SERVICE DIRECTIVE BULLETIN NO. 0104

DATE: October 6, 2008

1. SUBJECT: Possible Interference Involving Main Rotor Pitch Change Bellcrank (Cyclic Walking Beam)
2. MODEL: F-28A, F-28C, F-28F, 280, 280C, 280F, and 280FX
3. EFFECTIVITY: All Serial Numbers
4. BACKGROUND:

Figure 1. Damage to ear of bellcrank.

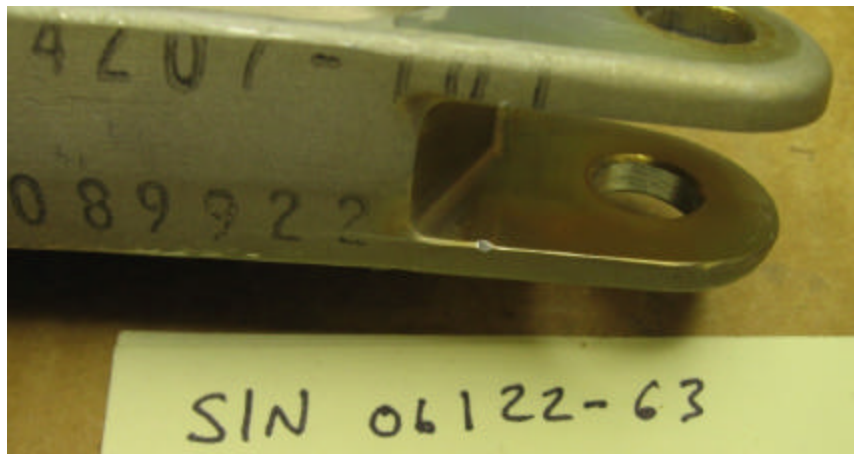
Enstrom received a field report of damaged pitch change bellcranks, P/N 28-14207-101. The damage was caused by interference between the pitch change bellcranks and the end fitting in the main rotor control rods. This interference only occurs if the collective system is mis-rigged. If the collective system is mis-rigged, the interference may be encountered when the collective is in the full down position and the cyclic stick is moved through a full travel control system check as part of a preflight check.

- A. Inspect the pitch change bellcranks for contact damage by moving the collective to the mid-range position and using a mirror to inspect for damage or disconnect the pitch change bellcranks from the main rotor control rods and the bellcrank brackets. Follow the procedures for collective friction use and removing the pitch change bellcranks as found in the applicable F-28/280 Series Maintenance Manual. If contact damage is found (see Figure 1 for example), refer to paragraph 5.2 for repair procedures and check the rigging of the collective system at the bottom of the main rotor gearbox IAW paragraph 5.1.B. If no contact damage is found, perform the collective system rigging check at the next 100 hour/annual inspection.

- A. Remove the Pitch Change Bellcranks from the helicopter following the procedures in the applicable F-28/280 Series Maintenance Manual.
- B. Replace pitch change bellcranks with damage exceeding .040" / 1.01mm in depth. Using a small file or other suitable device remove the contact damage from the ears of the pitch change bellcranks; blend the repair area over the length of the ear (the repair cannot exceed 0.040" / 1.01mm in depth). Apply a protective coating of epoxy primer (Desoto #593 X 300 or equivalent) to the repair area.
- C. Reinstall the Pitch Change Bellcranks following the procedures in the applicable F-28/280 Series Maintenance Manual.

Figure 2. Required clearance between the collective bearing housing and the swashplate mount flange

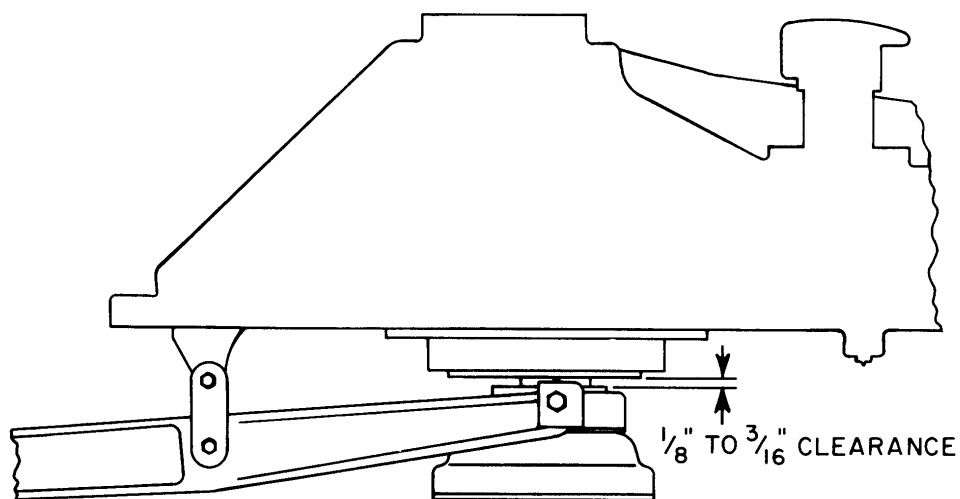
- B. Inspect the rigging of the collective system at the bottom of the main rotor gearbox for 1/8" to 3/16" (.125" to .1875" / 3.18mm to 4.76mm) clearance between the collective bearing housing and the swashplate mount flange (See Figure 2). Refer to the applicable F-28/280 Series Maintenance Manual for the rigging procedures.

The collective rigging procedures in the F-28A/F-28C and 280/280C Maintenance Manuals do not list the dimensional requirements found in paragraph 5.1.B of this SDB. When performing the collective rigging check on the F-28A/F-28C and 280/280C model helicopters, include the dimensional requirements in paragraph 5.1.B as part of the collective rigging requirements. The dimensional clearance is set by adjusting the length of the control rod connecting the collective torque tube bellcrank to the collective walking beam.
